# Access Compliance Report

## Public Rights-of-Way

Intersection ID: 48463	Main Street: PANGLEMONT_DR	Cross Street: CHANDLER_HAVEN_DR	Location: S
ADA ID: E065CBB5CF34	Ramp Type: PerpDiag	Initial Pass/Fail: Fail	Overall Compliance: No
Severity Score: 13.75			
Codes/Mitigation Info/Possible Solution		Field Measurements/Component Compliance

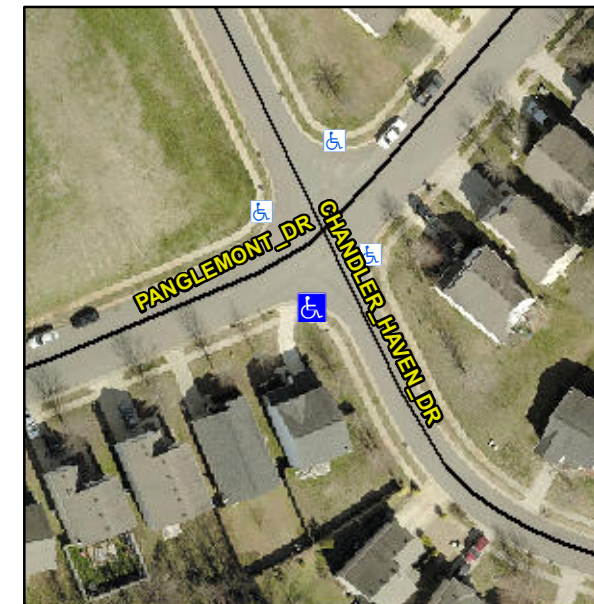
**Not Found, R304.2.2, R304.5.3**

Compliance	Description	Data	Compliance	Description	Data
N/A	Ramp Length (in)	45.5	No	Ramp Slope (%)	8.7
Yes	Ramp Width (in)	48.0	No	Ramp XSlope (%)	5.0
N/A	Flare Type LT	N/A	N/A	Flare Type RT	N/A
N/A	Flare Slope LT (%)	N/A	N/A	Flare Slope RT (%)	N/A
N/A	Flare Traversable LT?	N/A	N/A	Flare Traversable RT?	N/A
N/A	Landing Length (in)	N/A	N/A	DWS Provided?	N/A
N/A	Landing Width (in)	N/A	N/A	DWS Contrast?	N/A
N/A	Landing Slope (%)	N/A	N/A	DWS Length (in)	N/A
N/A	Landing X Slope (%)	N/A	N/A	DWS Full Width?	N/A
N/A	Landing Curb? (Y/N)	N/A	N/A	DWS Offset (in)	N/A
N/A	Shared Landing?	N/A			
N/A	Gutter Ponding?	N/A	N/A	Gutter Slope (%)	N/A
N/A	Gutter Lip Ht (in)	N/A	N/A	Gutter X Slope (%)	N/A
N/A	Painted X Walk1?	No	N/A	Painted X Walk2?	No
	X Walk 1 Direction	To NE		X Walk 2 Direction	To N
N/A	X Walk 1 Width (in)	N/A	N/A	X Walk 2 Width (in)	N/A
	X Walk 1 Slope (%)	0.6		X Walk 2 Slope (%)	4.0
	X Walk 1 X Slope (%)	4.2		X Walk 2 X Slope (%)	2.2

**Remove & Replace Curb Ramp With Two New Directional Ramps or Equivalent.**
